From: Chris Merritt <chris@olyeng.com>
Sent: Wednesday, October 10, 2018 4:13 PM
To: Jeff Fant
Cc: Steve Thompson; Paula Smith
Subject: By-Pass Flow Conveyance - Amended Plan
Attachments: Prelim Drainage Plan Amendment.pdf

*RECEIVED FOR REVIEW
CP&D Engineering
11-Oct-18 #18-1315*

WELLINGTON HEIGHTS

PRELIMINARY DRAINAGE PLAN AMENDMENT

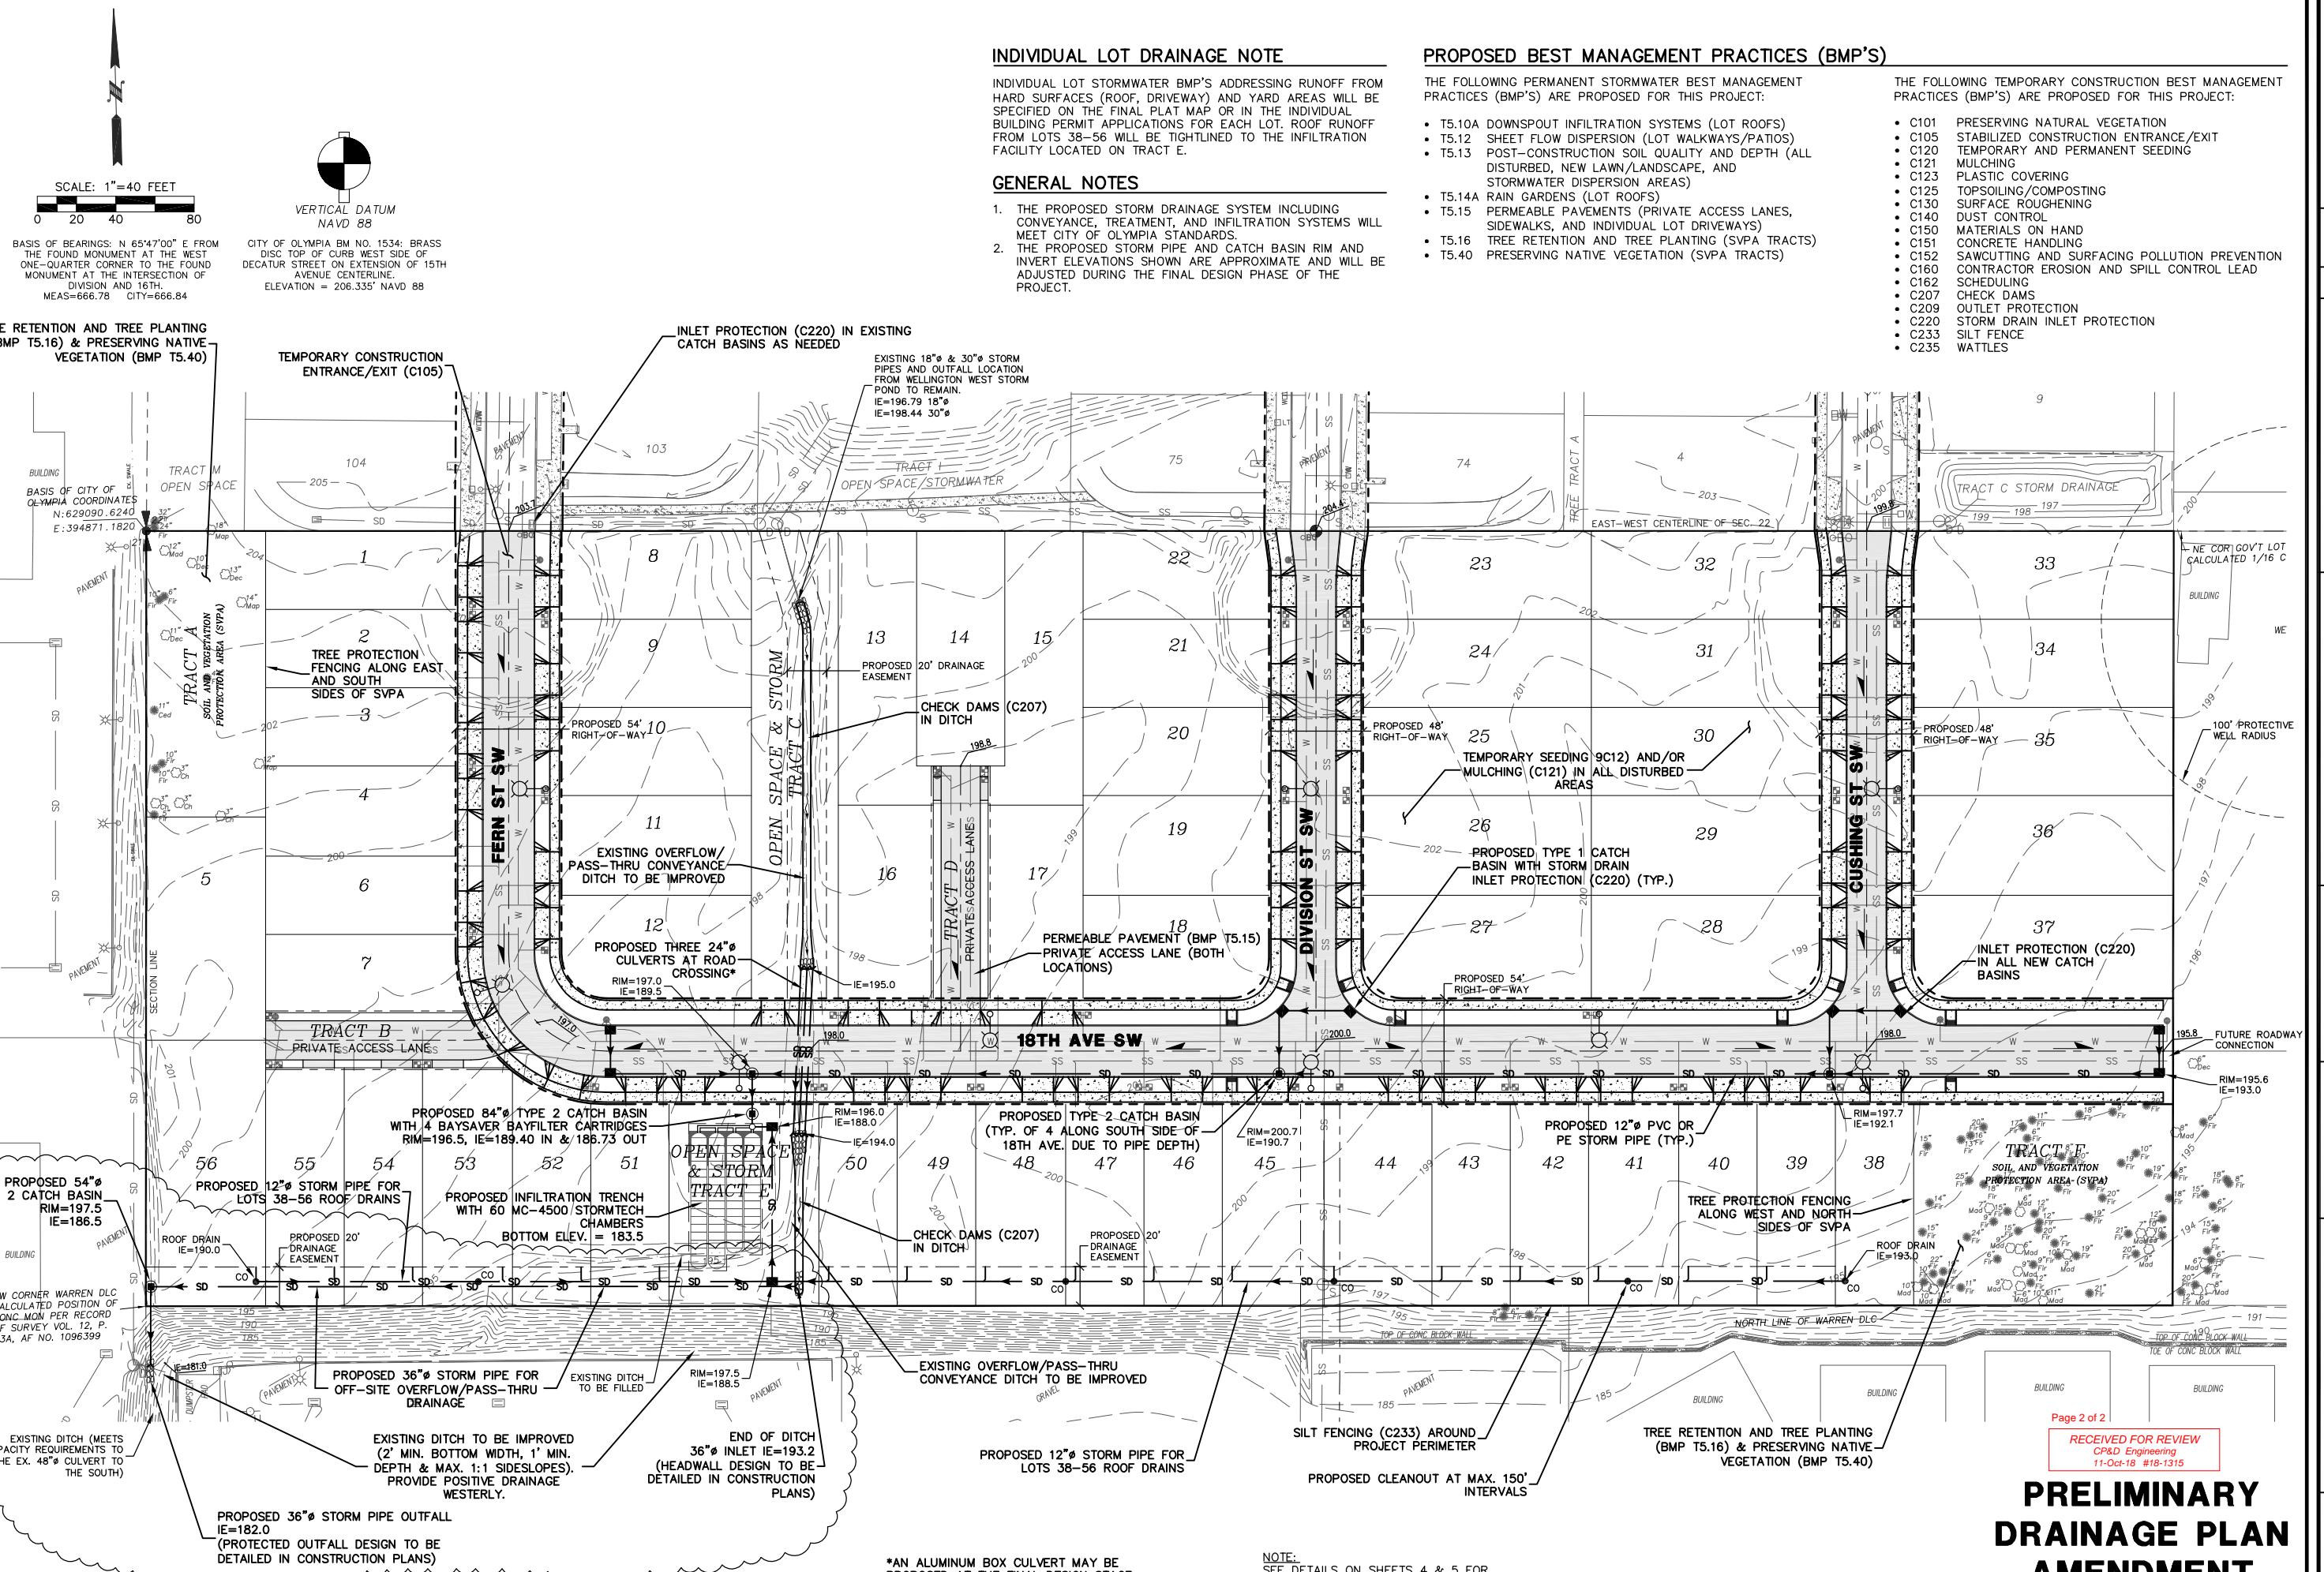
Attached is an amended drainage plan. We increased the storm pipe size to 36" diam. for an additional safety factor and to enable us to shallow up the pipe slope to 2%. At a 2% slope, the 36" pipe can convey up to 100-cfs. Also, we shifted the 36" pipe inlet location easterly to line up with the end of the north-south conveyance ditch and we shifted the outfall location westerly so it's contained entirely within the existing off-site easement.

Design details on the inlet headwall and outfall protection will be provided in the future construction plans.
